## SITE PLAN REVIEW SHEET ENVIRONMENTAL VARIANCE REQUEST ONLY

**CASE:** SP-2021-0091C

**PROJECT NAME:** Oltorf Site Plan

- 1) Request to vary from LDC 25-8-301 to allow driveways on slopes over 15%.
- 2) Request to vary from LDC 25-8-341 to allow cut over 4 feet up to 8 feet.
- 3) Request to vary from LDC 25-8-342 to allow fill over 4 feet up to 20.5 feet.

EXISTING SLOPE MAP

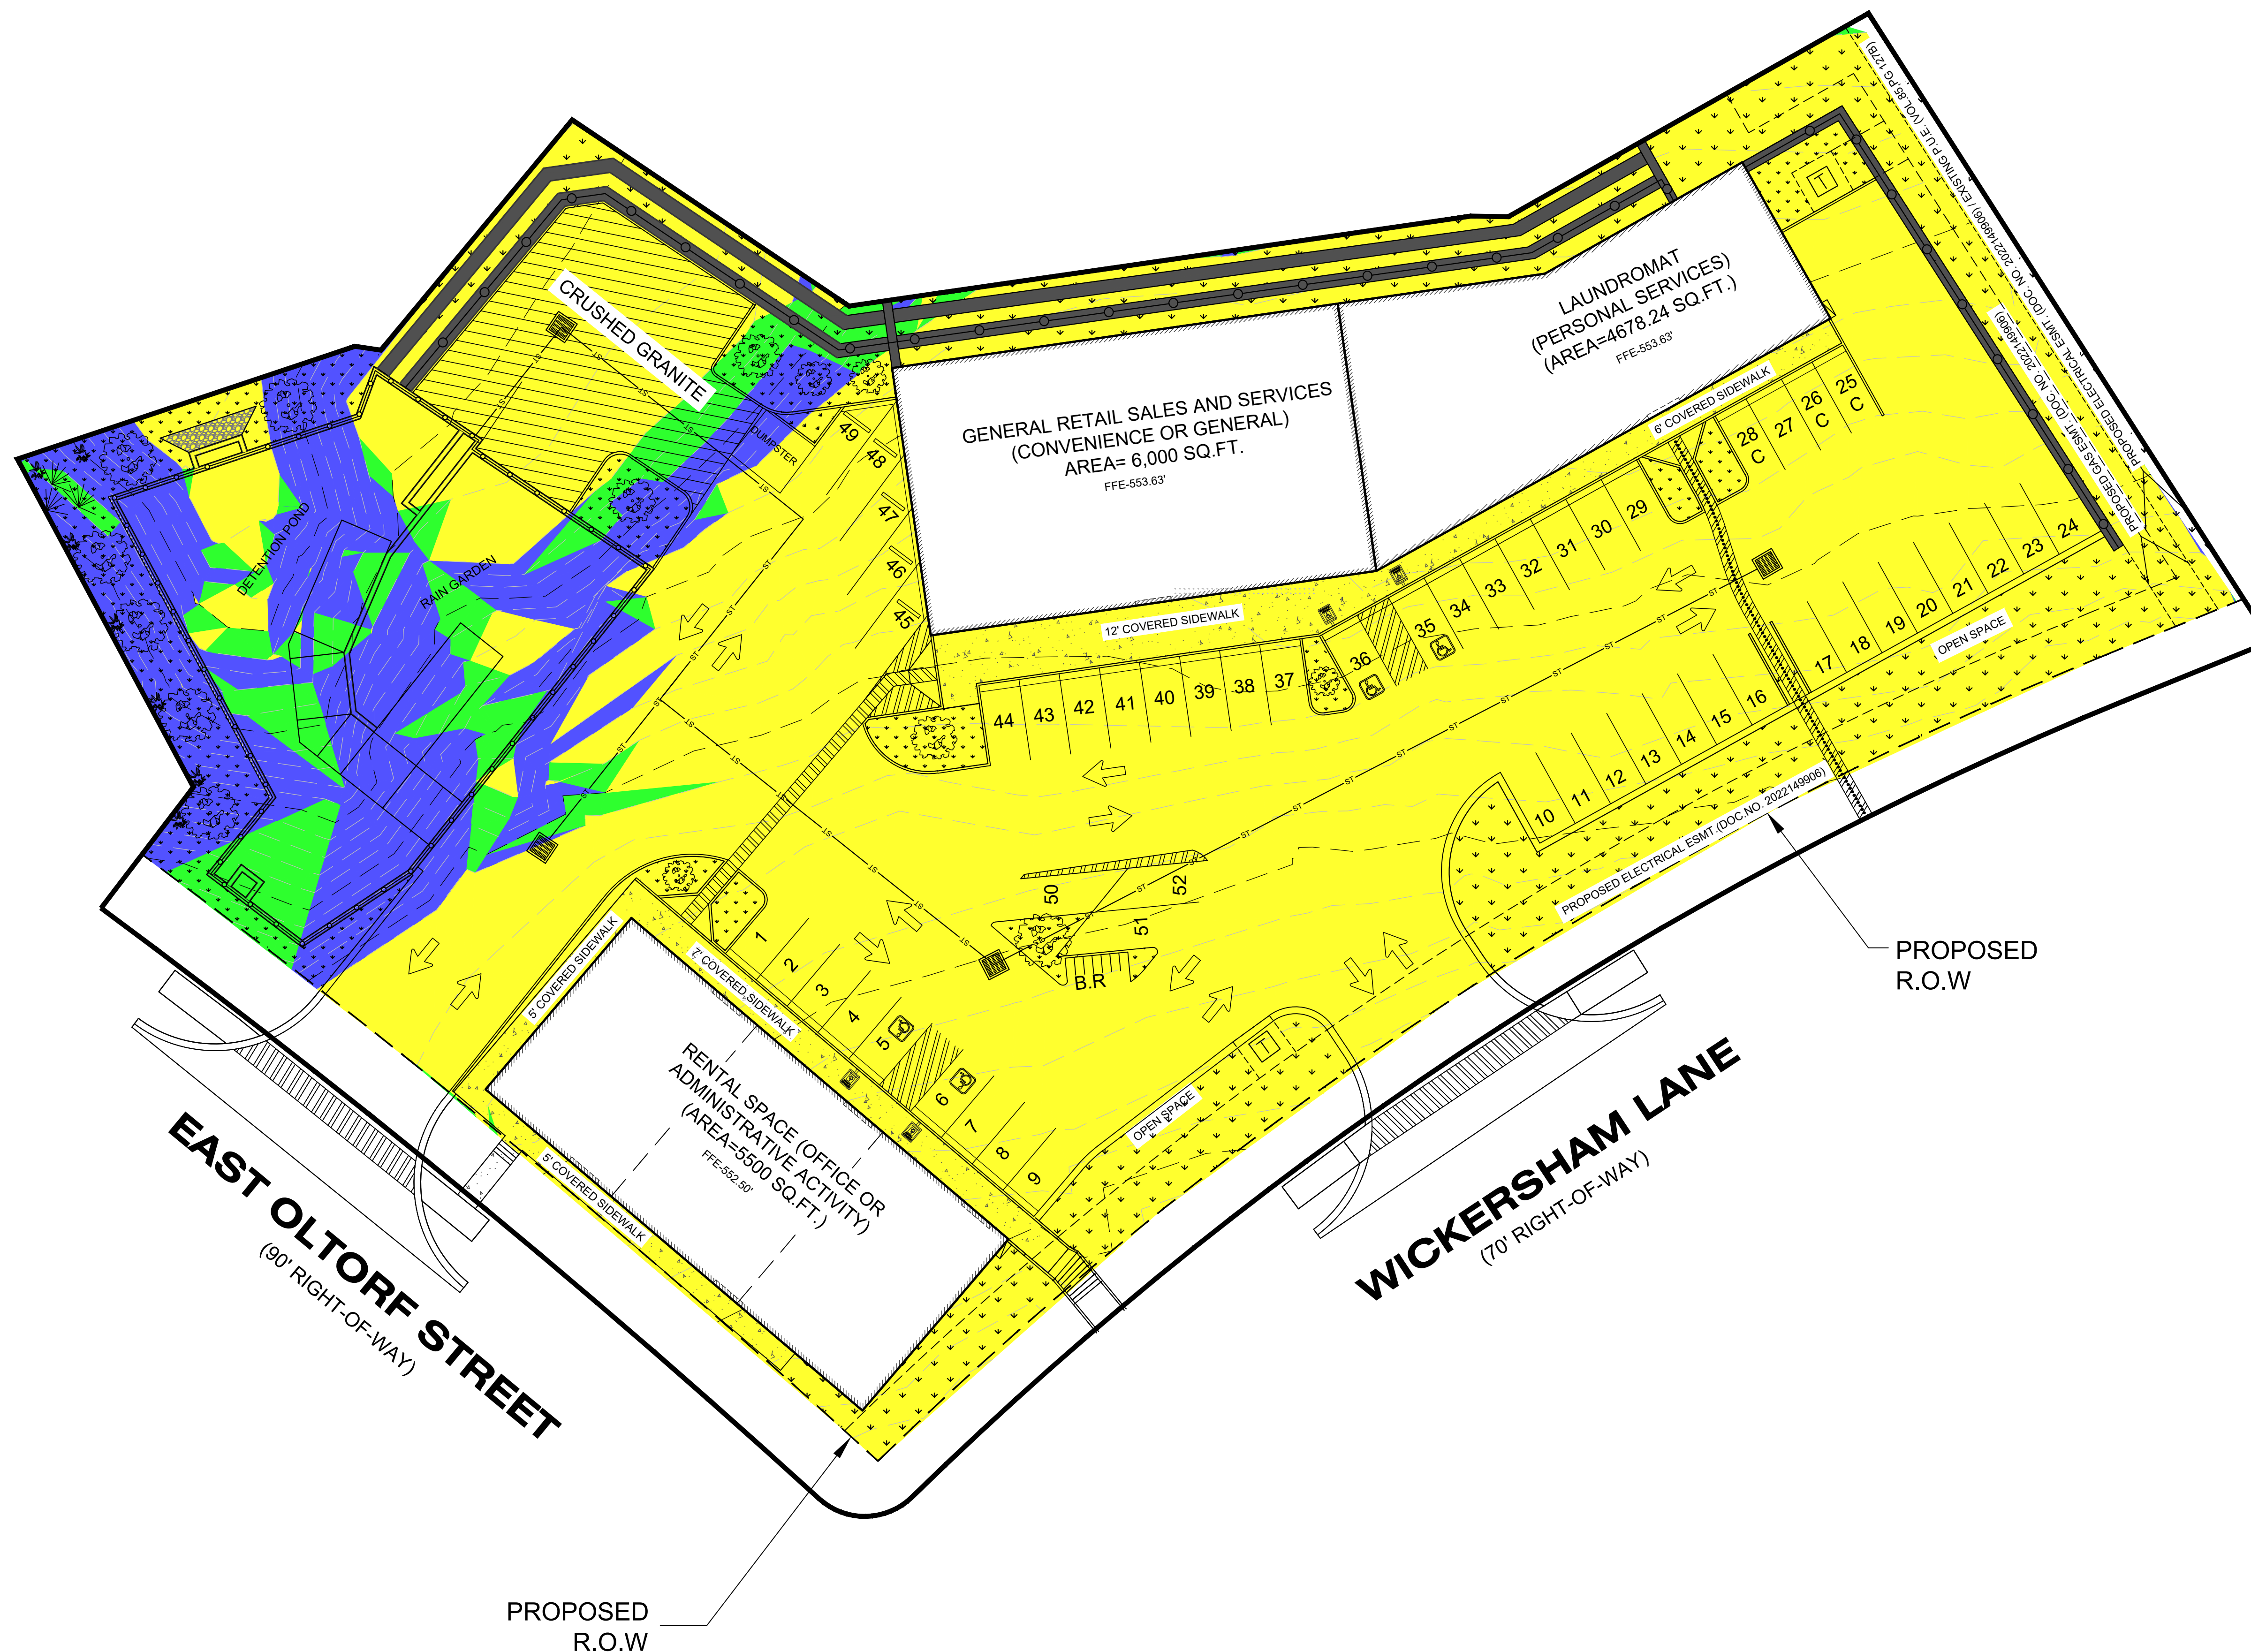
Project Name: Oltorf Site Plan  
 Ordinance Standard: Watershed Protection Ordinance  
 Variance Request: **To allow driveways on slopes over 15% per LDC 25-8-301**

Yes. Existing site conditions and accessibility regulations require the only available driveway access from Oltorf to cross existing slopes that exceed 15% gradient.

Staff Determination: Staff determines that the findings of fact have been met. Staff recommends the following conditions per approved exhibits:

- Provide 8 additional trees at 3 caliper inches.
- Provide structural containment of fill with retaining walls.

CUT/FILL EXHIBIT

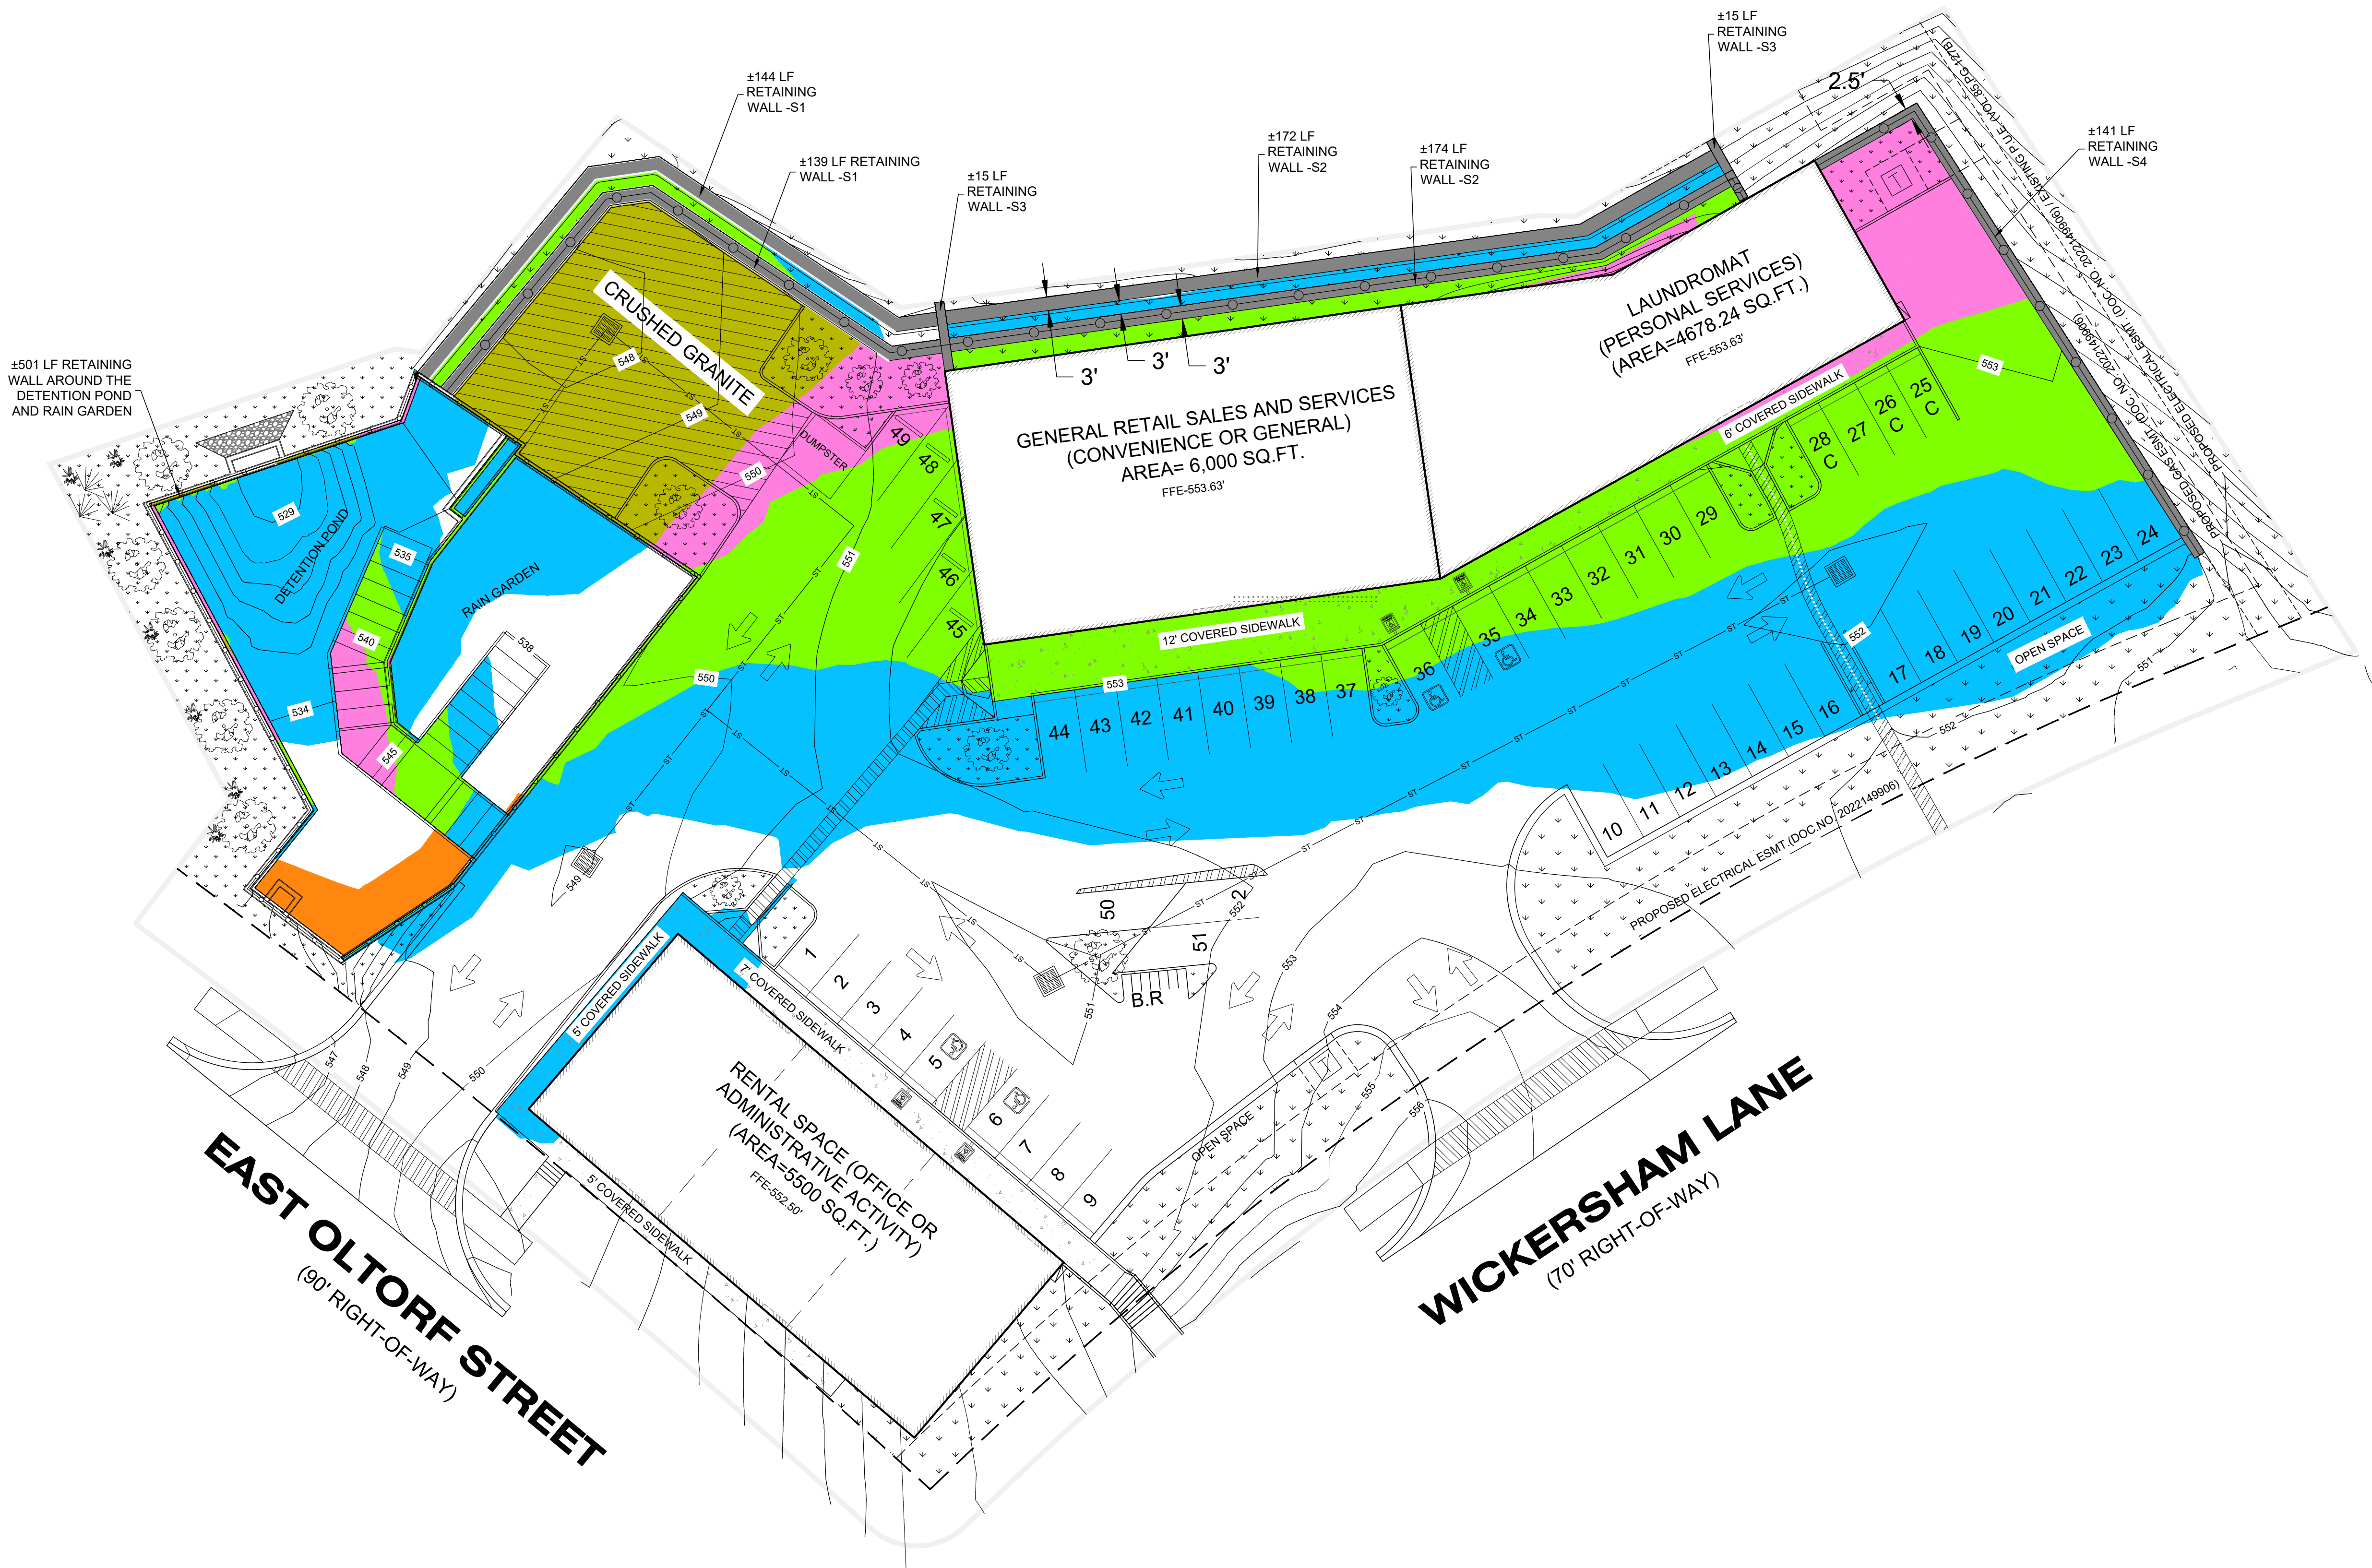
Project Name: Oltorf Site Plan  
 Ordinance Standard: Watershed Protection Ordinance  
 Variance Request: **To allow fill exceeding 4 feet up to 20.5 feet per LDC 25-8-342**

In order to facilitate this type of drainage which will require stormwater releases from detention ponds to flow into the storm sewer pipes along East Oltorf, grading within the detention/water quality area will have cut up to 8 feet and fill up to 20.5 feet.

Yes. The variance does not create a significant probability of harmful environmental consequences. The variance is a minimum deviation from code to allow for reasonable use of the property. Fill will be minimized and structurally contained with retaining walls.

Staff Determination: Staff determines that the findings of fact have been met. Staff recommends the following conditions per approved exhibits:

- Provide 8 additional trees at 3 caliper inches.
- Provide structural containment of fill with retaining walls.
